ADDENDUM NO. 02

Project: Conway Corporation
Roger Q Mills Jr.
Water Treatment Plant 8 MGD Expansion & Improvements

The Contract Documents dated May 3, 2024, are hereby amended as follows:

CEI JOB NO.: 2135
GARVER JOB NO.: 19W01300
DRAWING NUMBER
08-1725
SHEET NUMBER
053

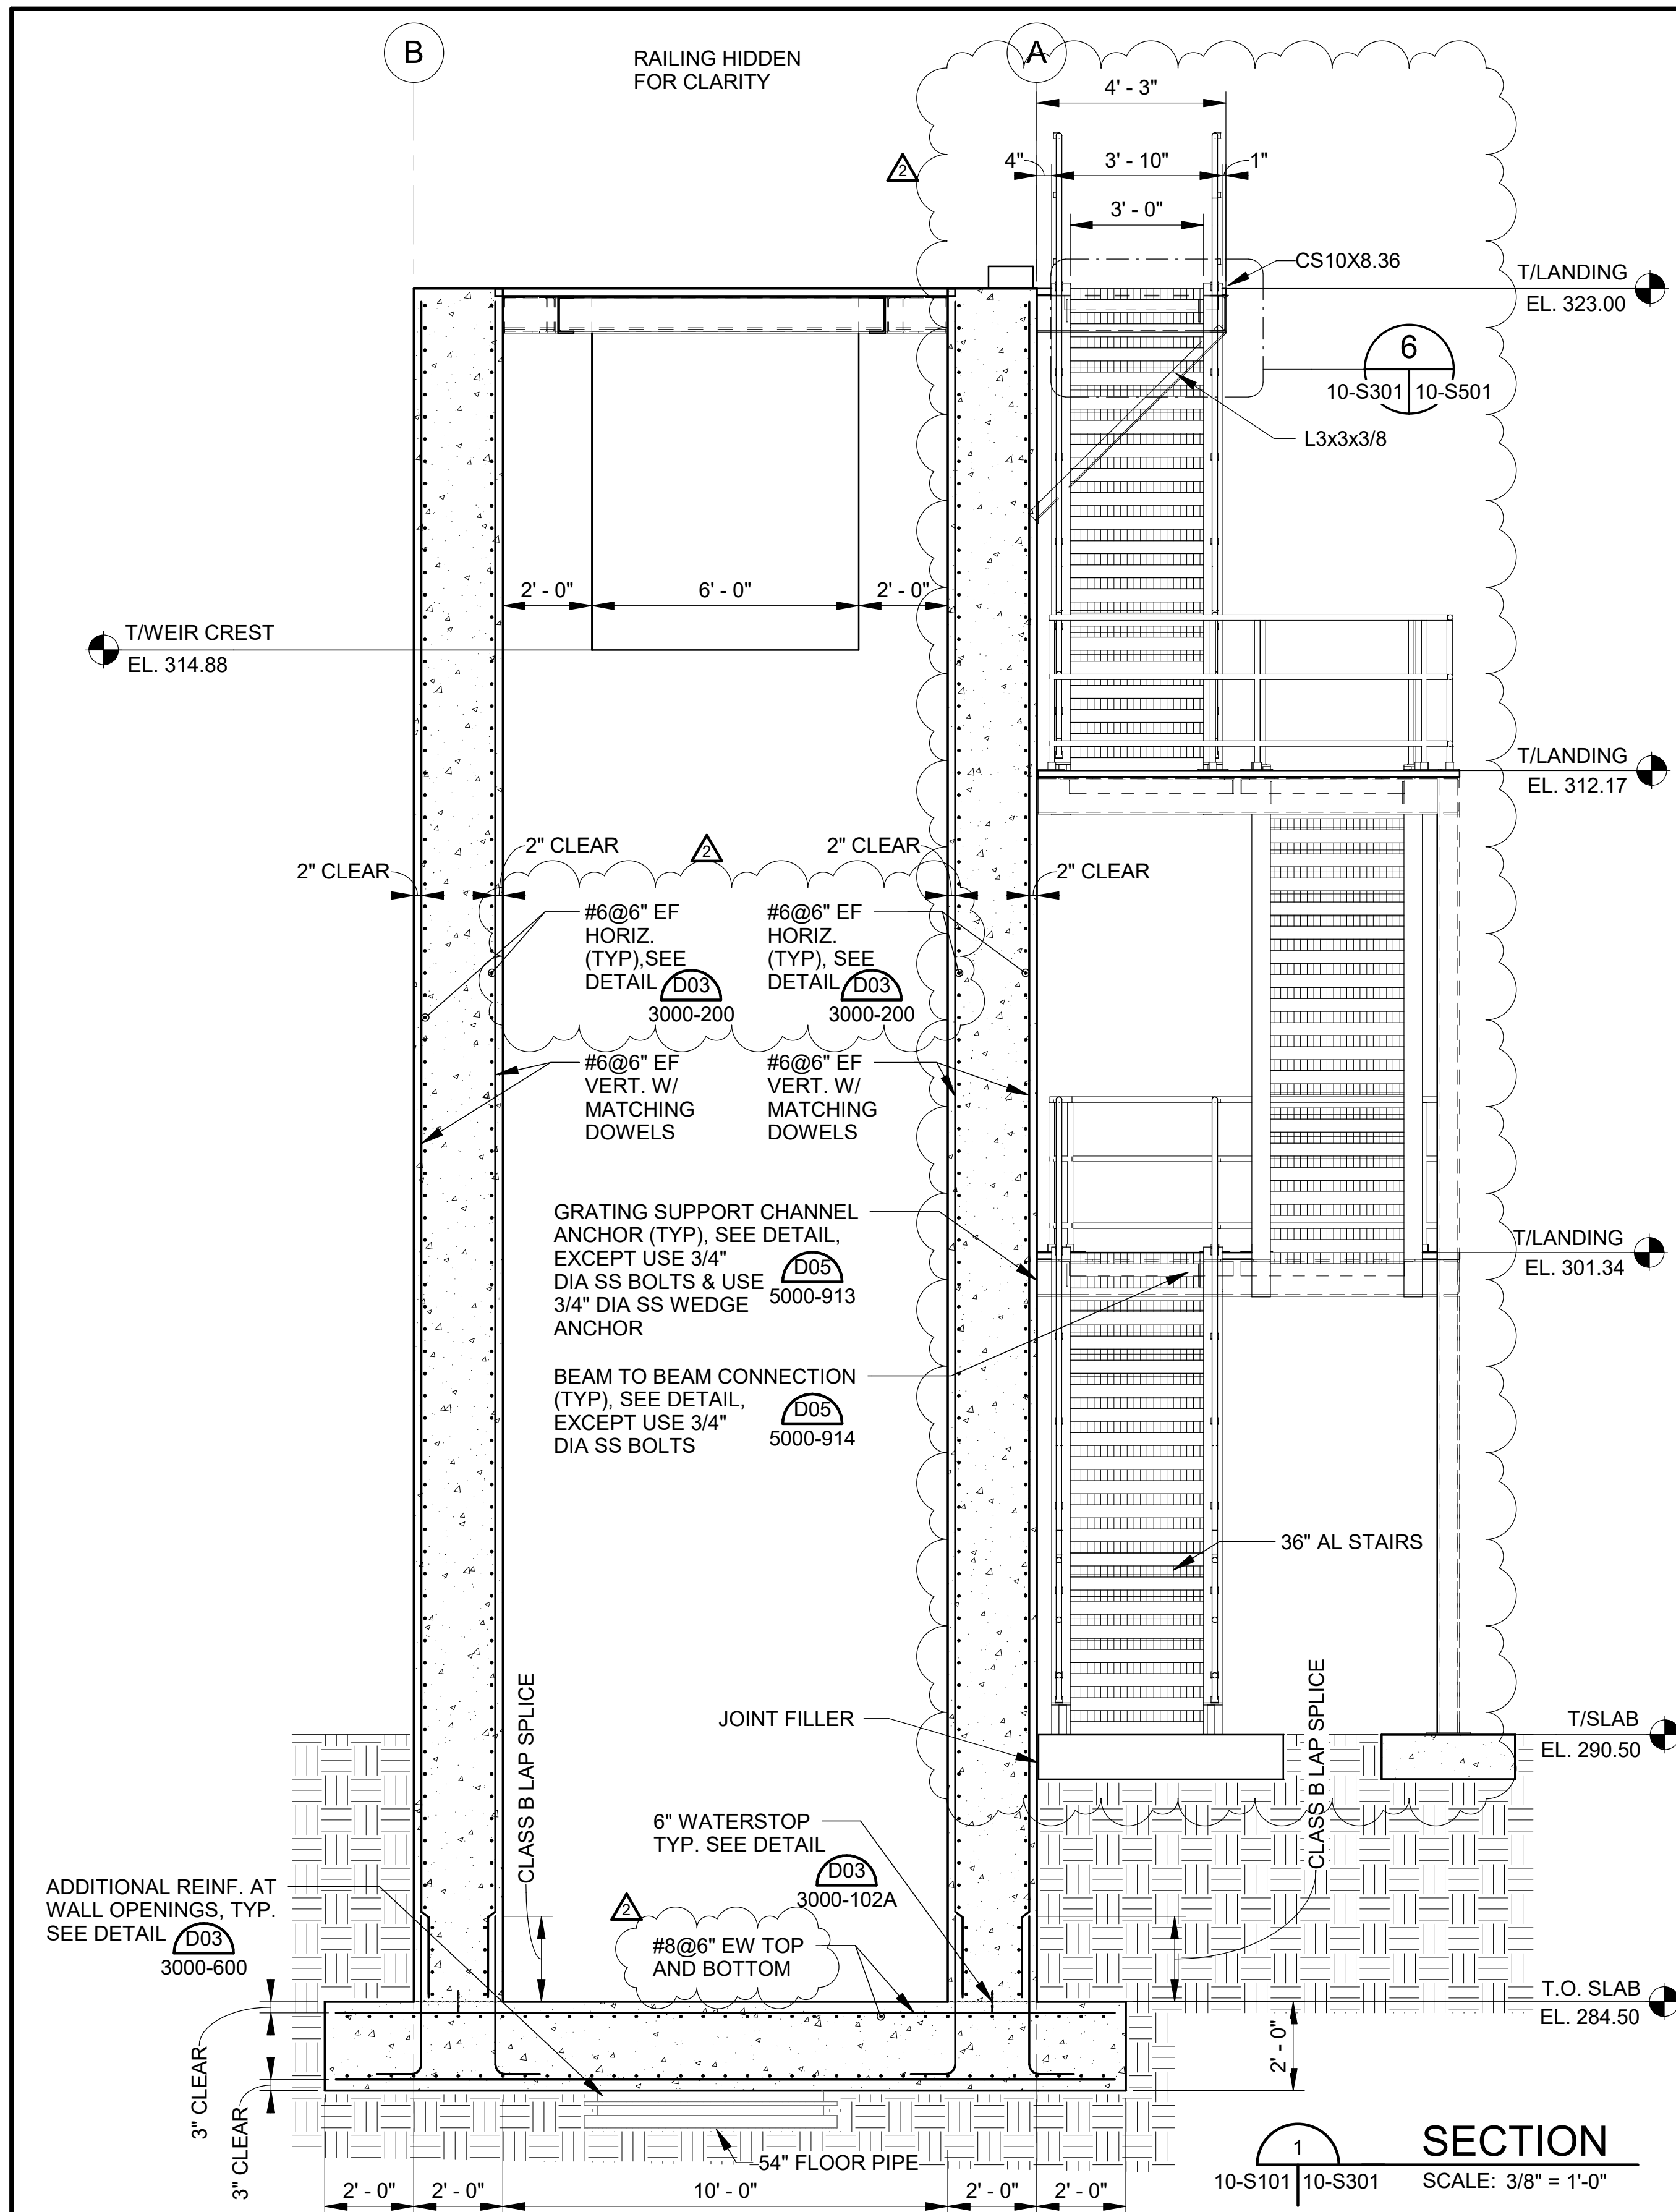
10. Drawing No. 08-I725 (Sheet No. 053)
 - a. Delete the entire drawing and replace it with Drawing No. 08-I725 – PAC FEED AND STORAGE P&ID 2- Addendum No. 02, attached hereto.

CEI JOB NO.:
2135
GARVER JOB NO.:
19W01300
DRAWING NUMBER
10-S301
SHEET
NUMBER **068**

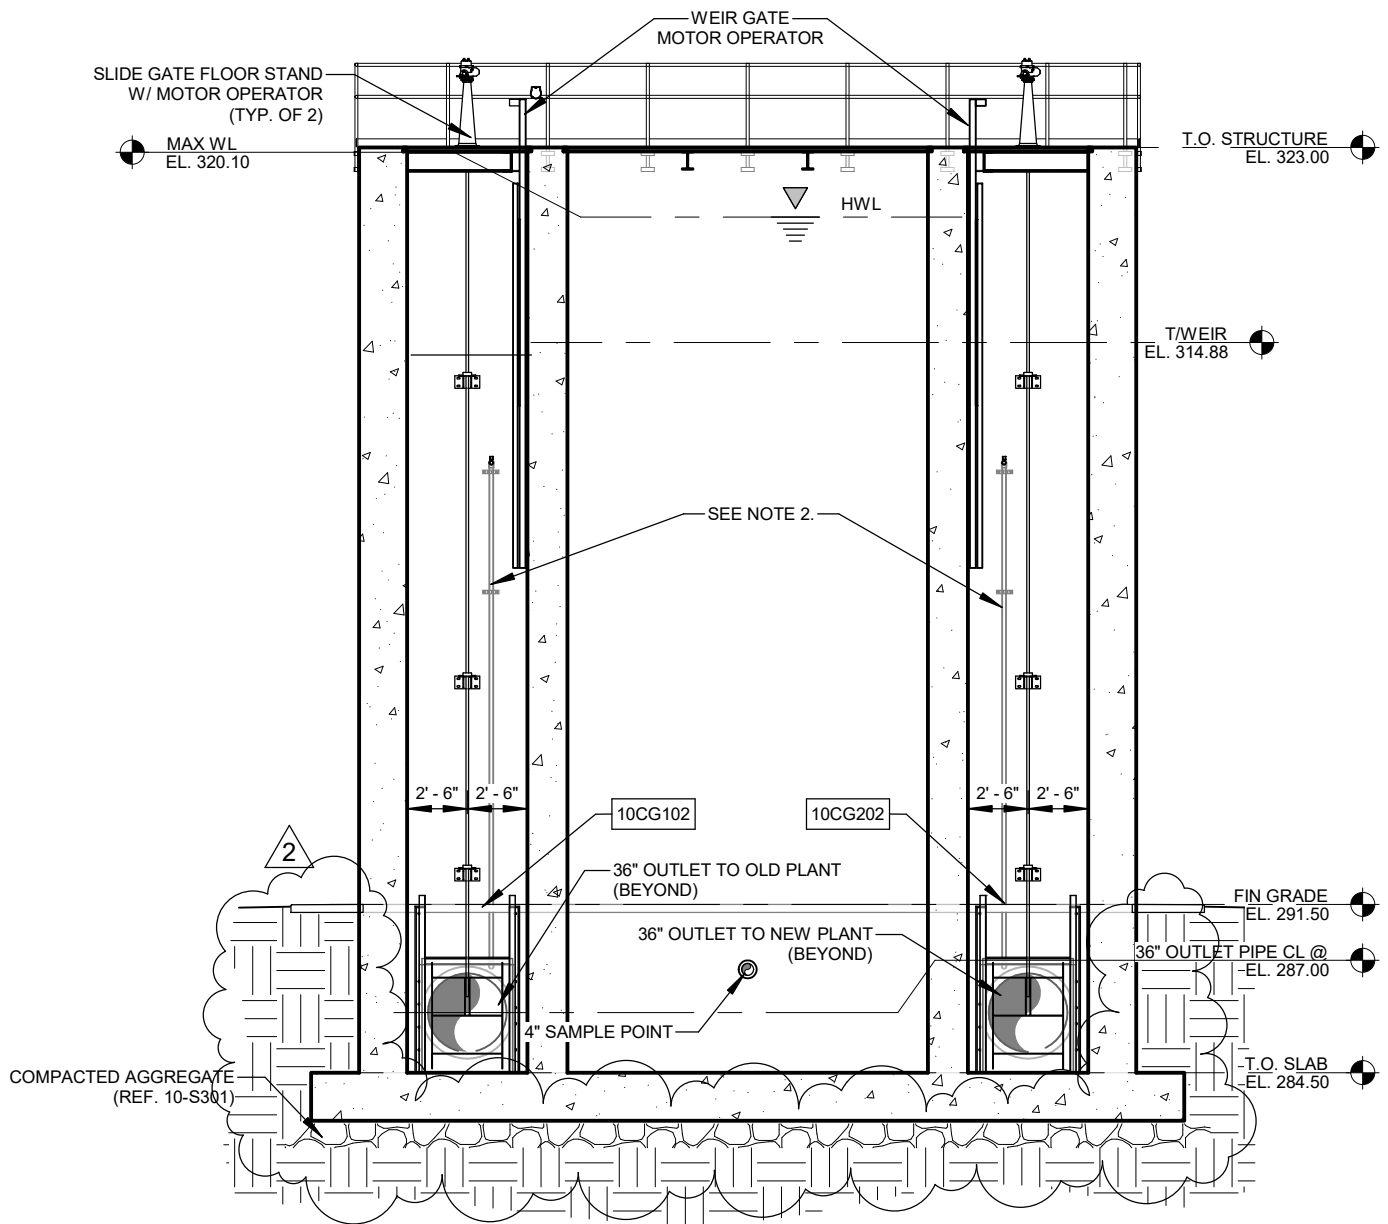
- a. Delete the entire drawing and replace it with Drawing No. 10-S301 - RAW WATER BLENDING STRUCTURE SECTIONS - Addendum No. 02, attached hereto.
12. Drawing No. 10-P301 (Sheet No. 078)

SECTION B - VAULT (TYP.)

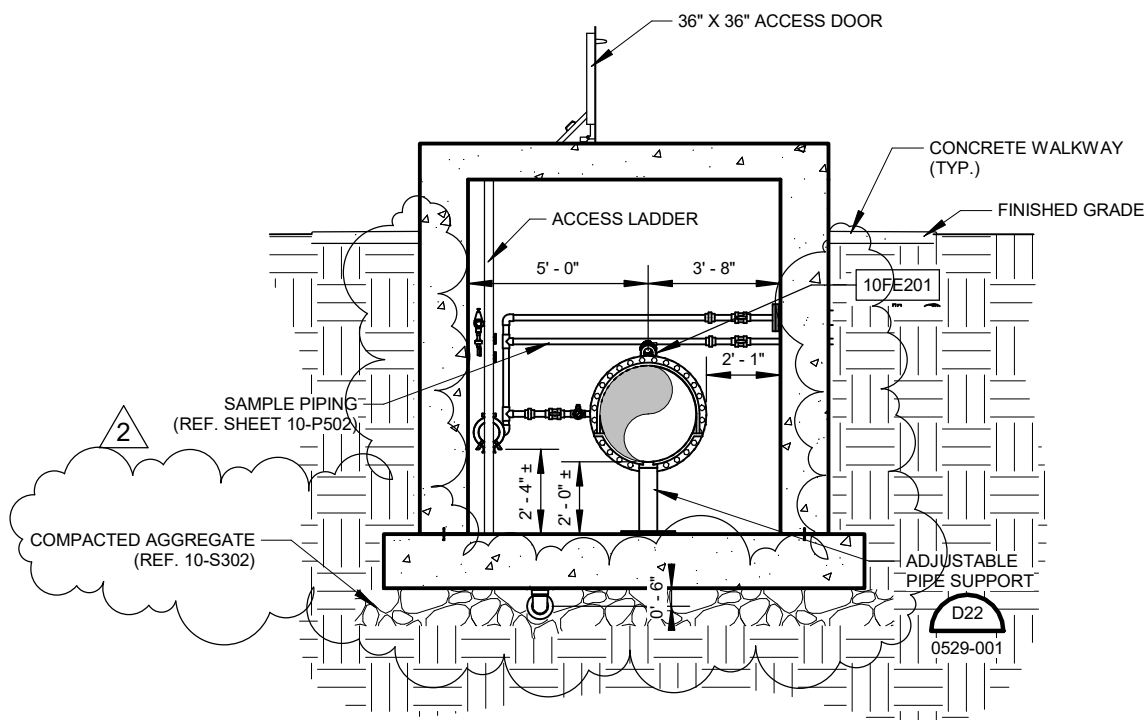
- a. Modify Section – Typical shown on the Process Mechanical Sections 1 – Addendum No. 02, attached hereto.
13. Drawing No. 10-P303 (Sheet No. 080)
 - a. Modify Section B – Vault (Typ.) shown on the Raw Water Meter Vault Section – Addendum No. 02, attached hereto.
